ADDENDUM NO. 4

PROJECT NAME: UNL Devaney Sports Center Improvements
UNL PROJECT NUMBER: C100P098

DATE OF ISSUANCE: Wednesday, April 11, 2012

LOCKER SECTION - VOLLEYBALL LOCKERS 107A

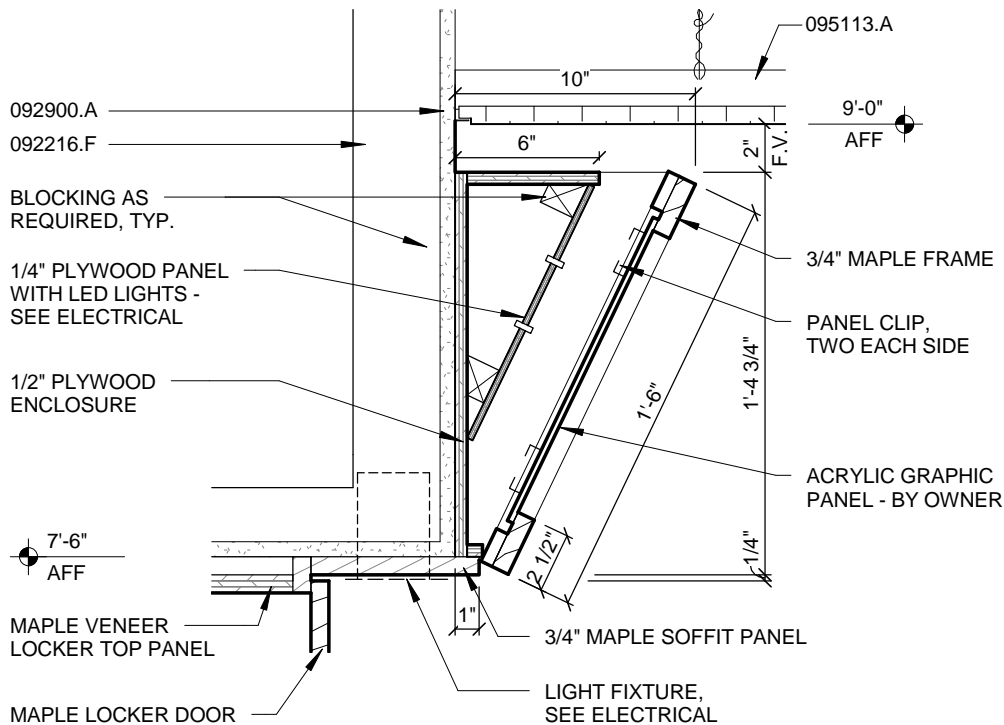
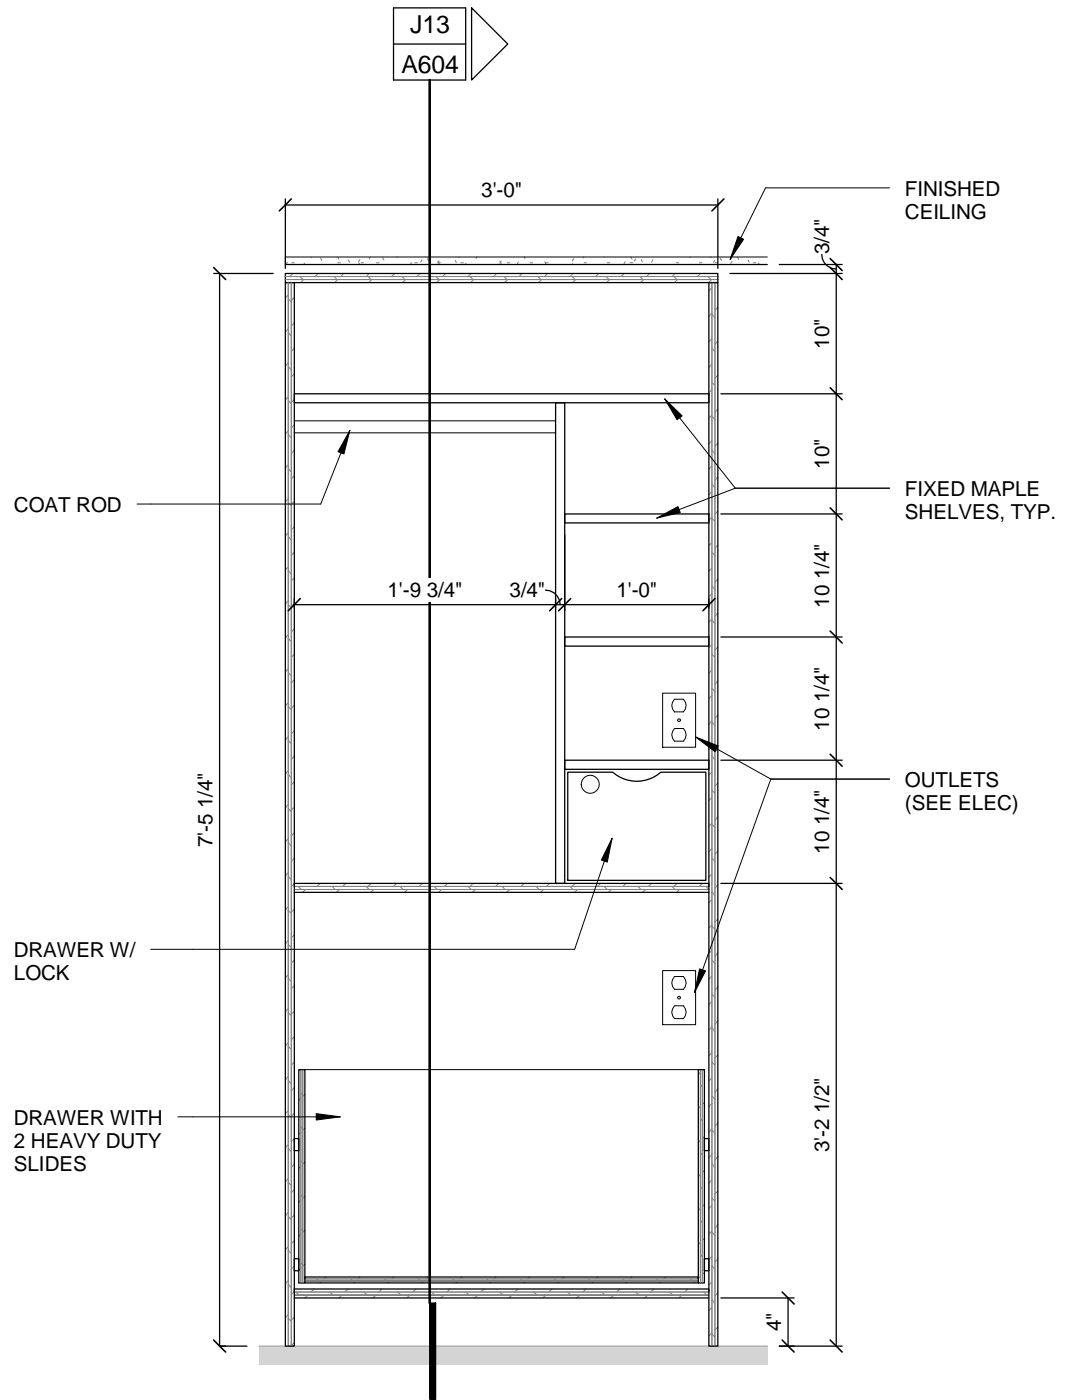
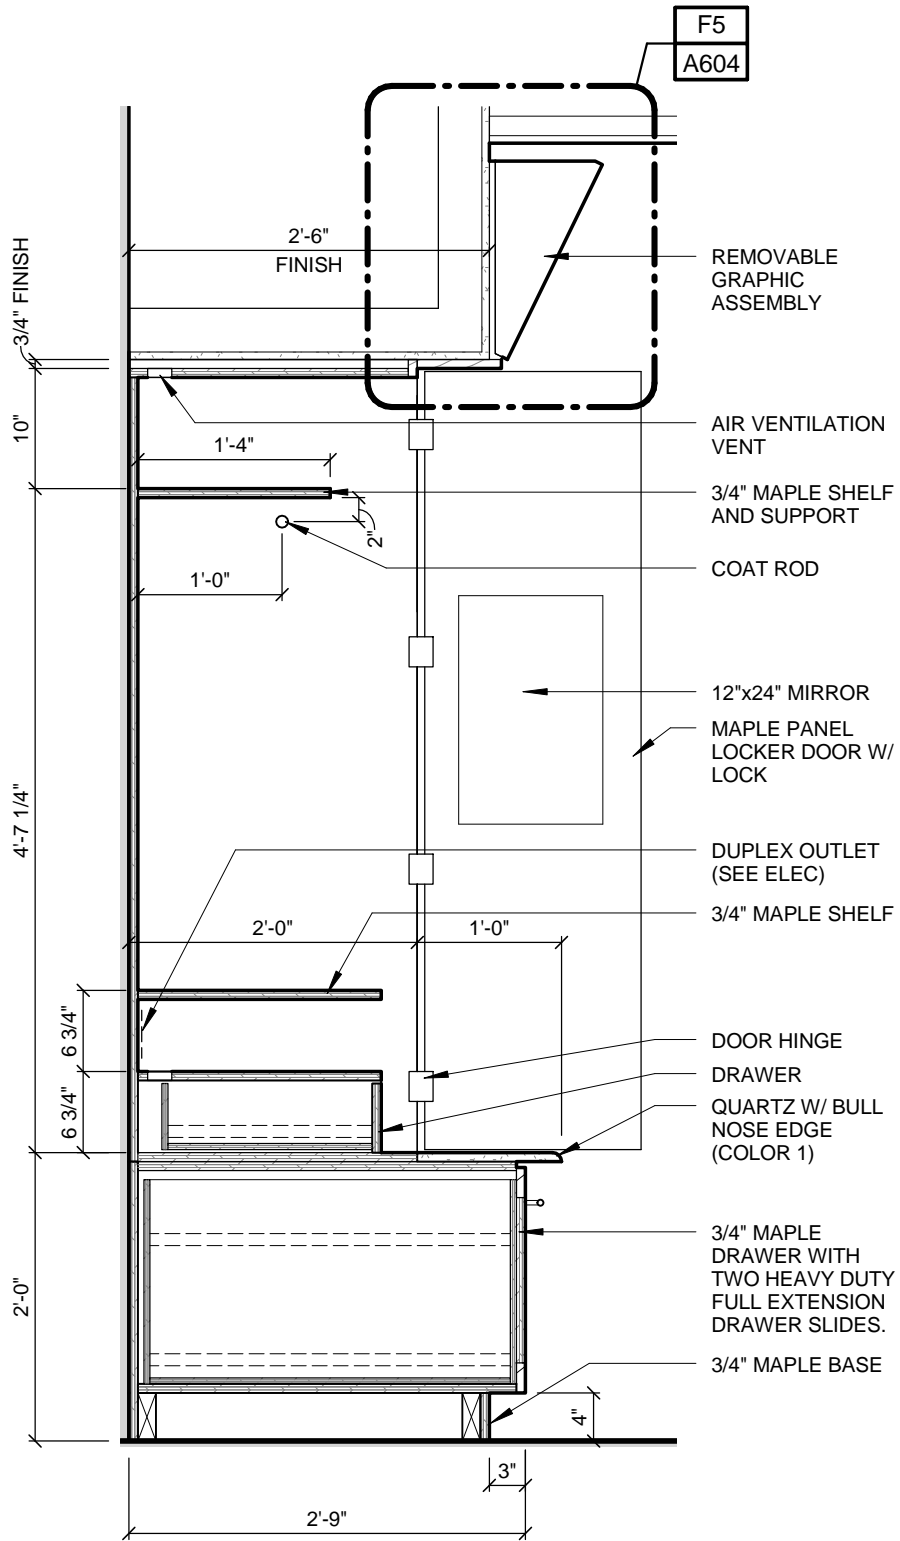
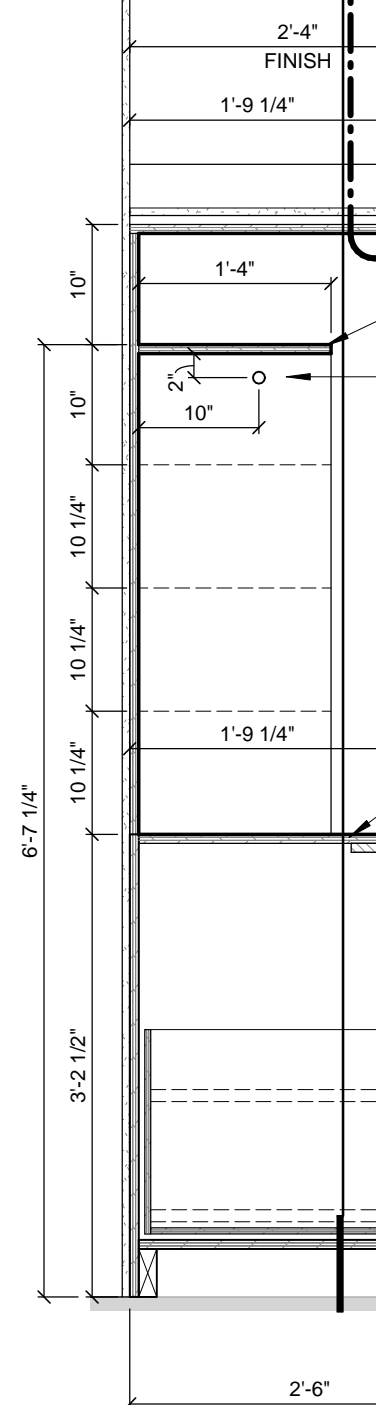
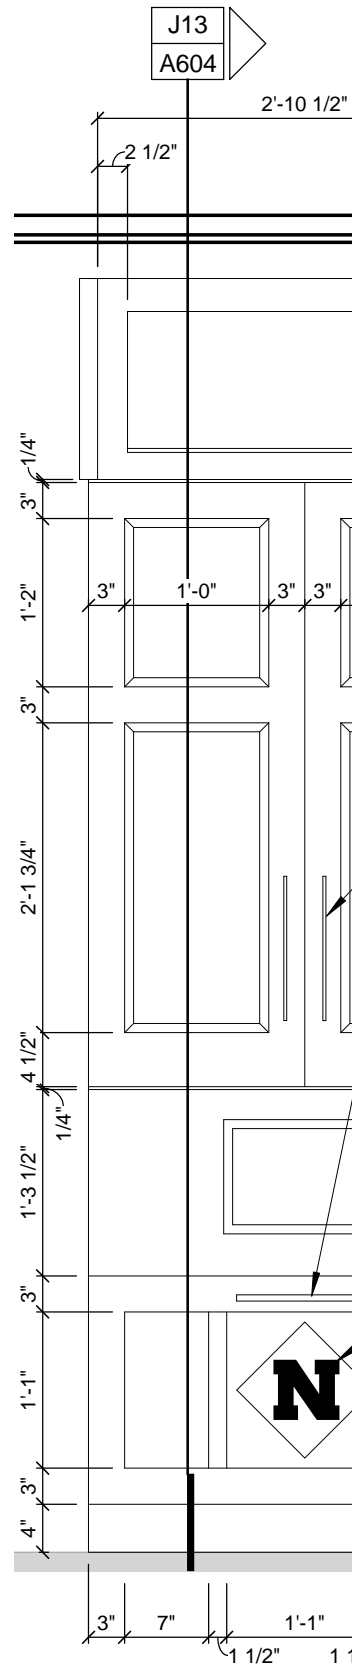
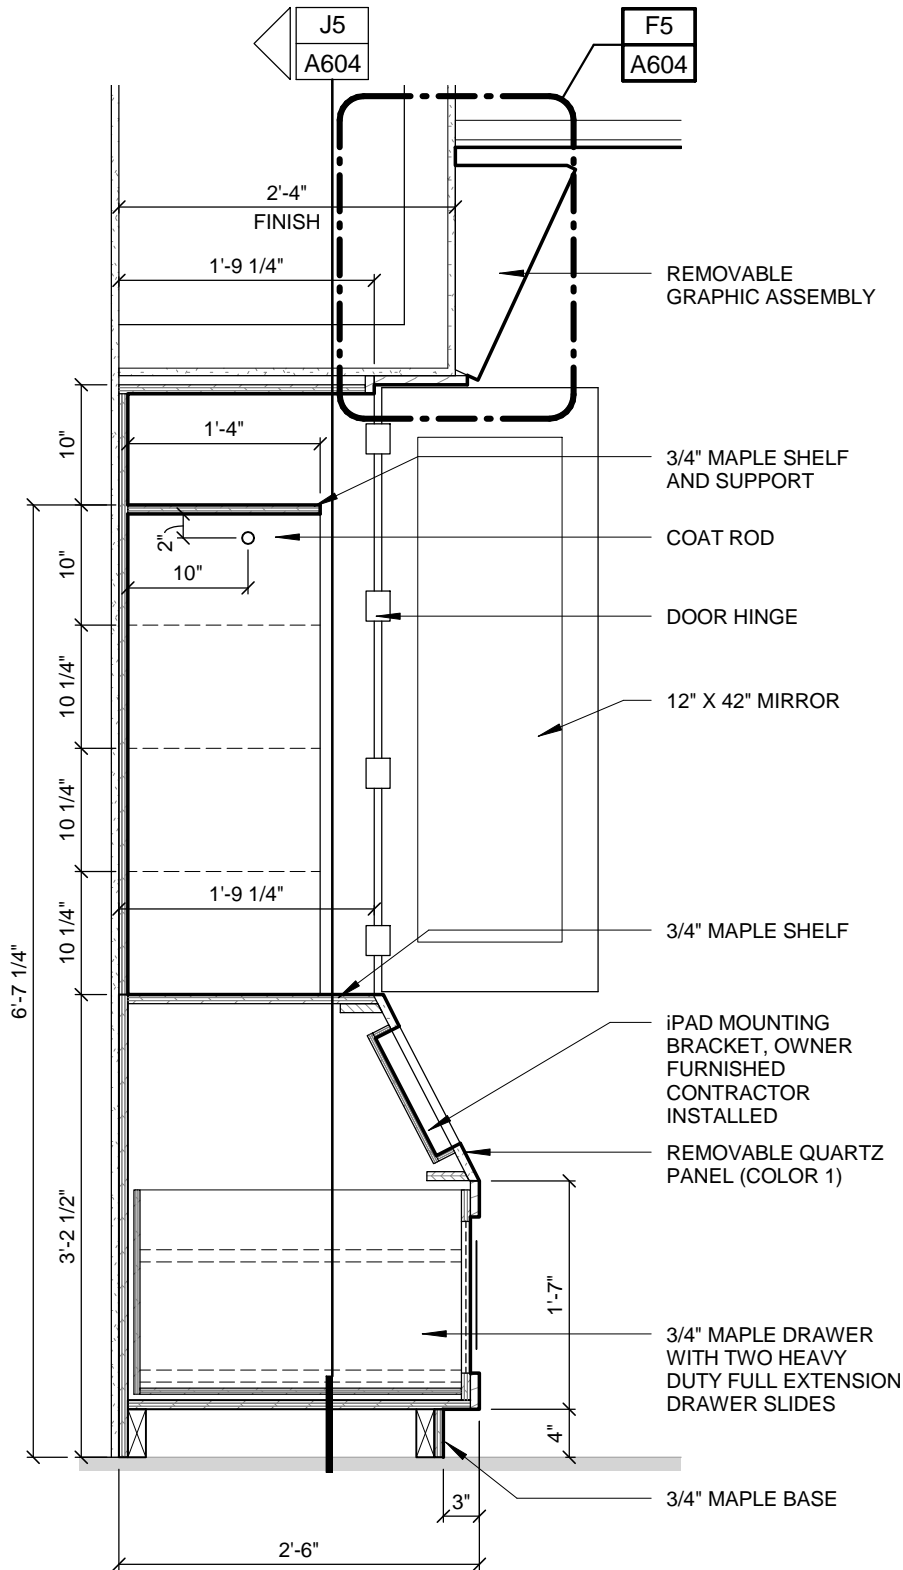
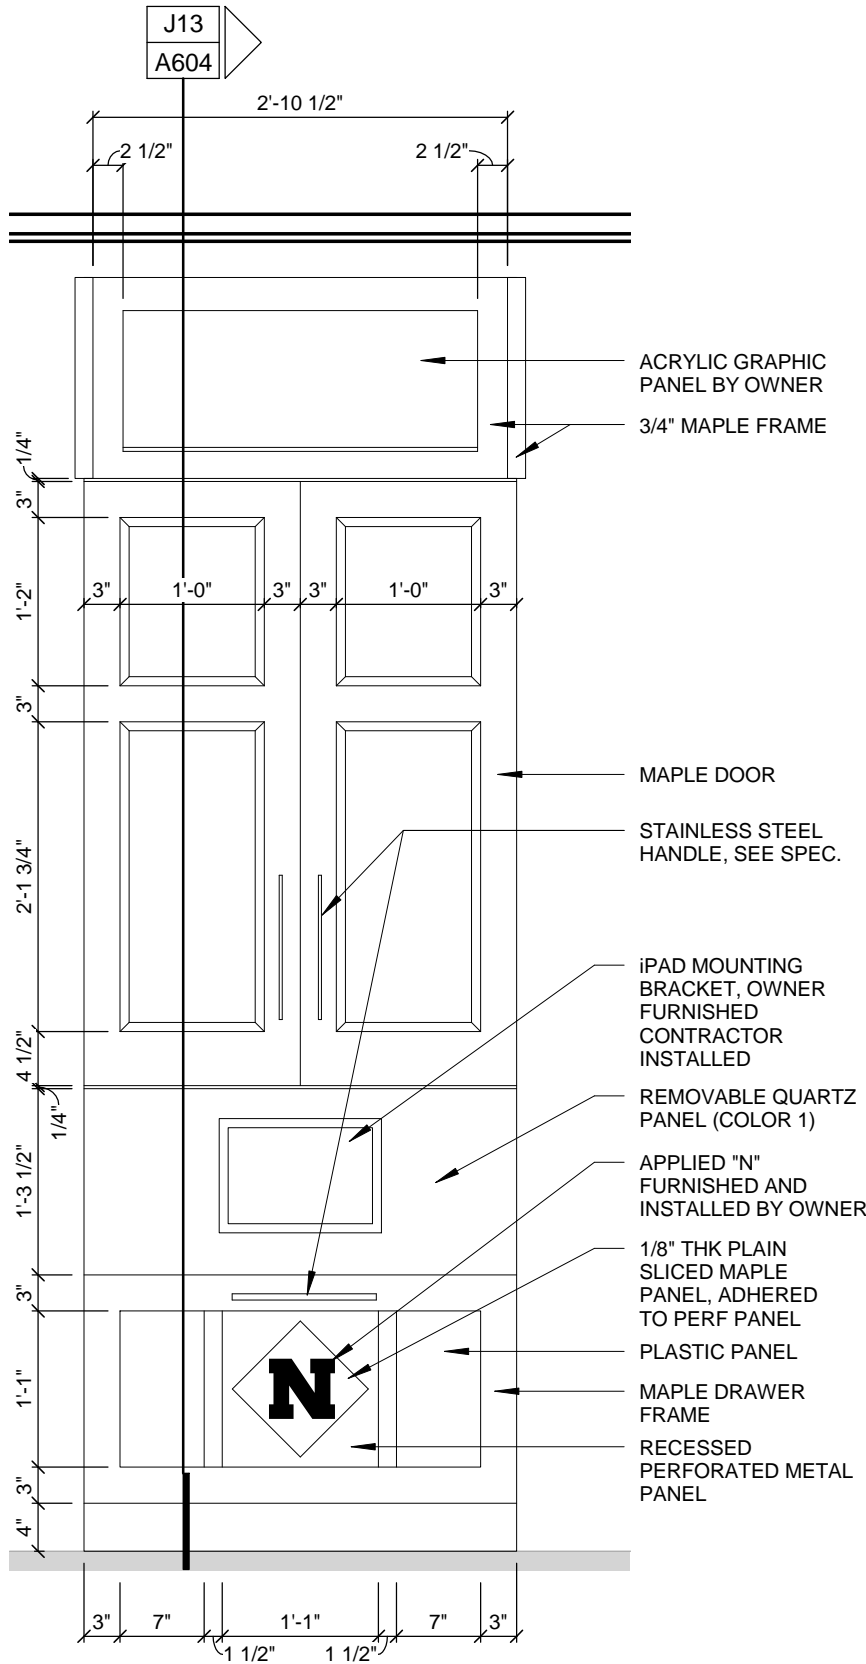
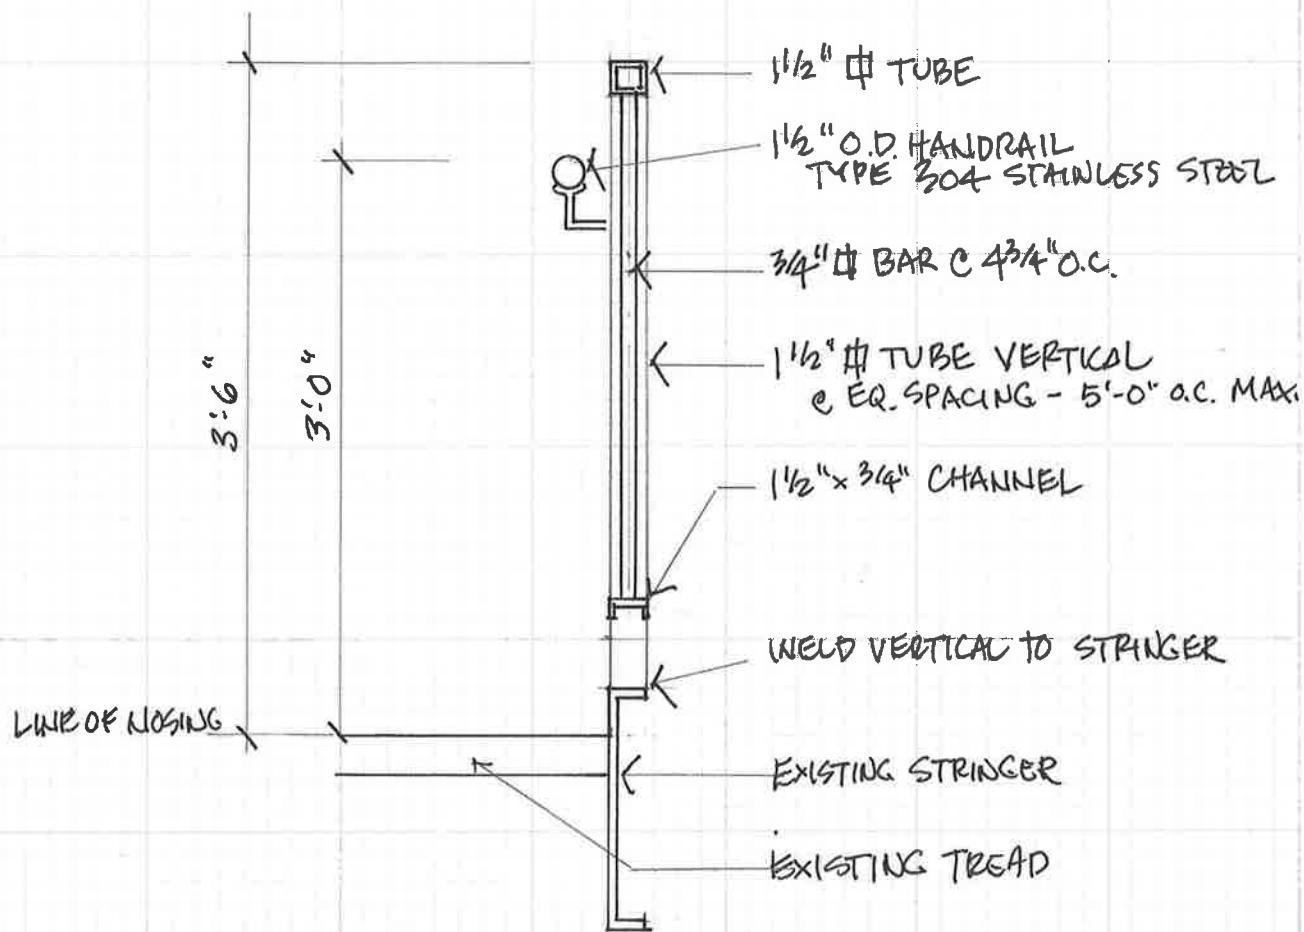
1. See the attached Details for the casework lockers in Volleyball Locker 107A and Gymnastic Locker 176A. (See Attachment).

Detail ← TYP. GUARDRAIL @ STAIR

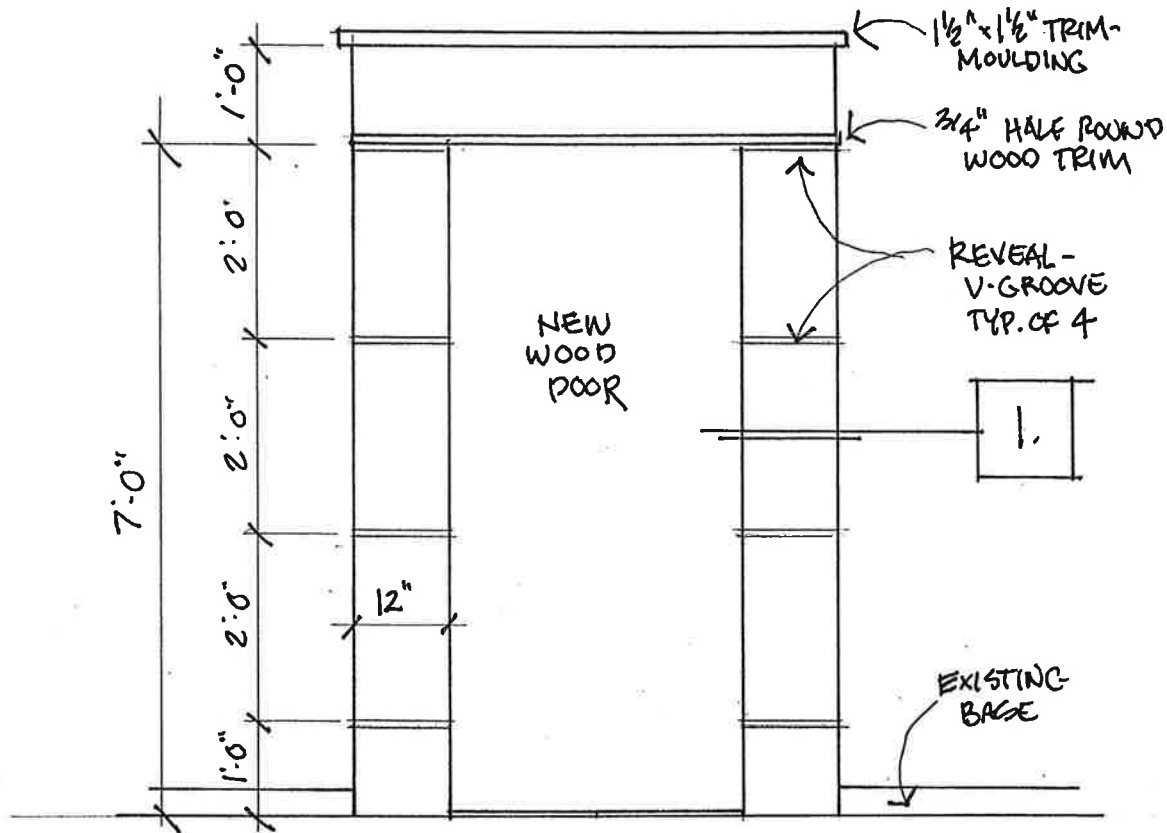
1. See the Attached sketch for the typical steel pipe guardrail and handrail to replace the rails at the existing NE, NW, SE and SW stairs. The detail of the new SW stair from Concourse to Club levels shall also match this detail. The guard steel shall all be painted. The handrail shall be Type 304 stainless steel with brushed finish. (See Attachment.)
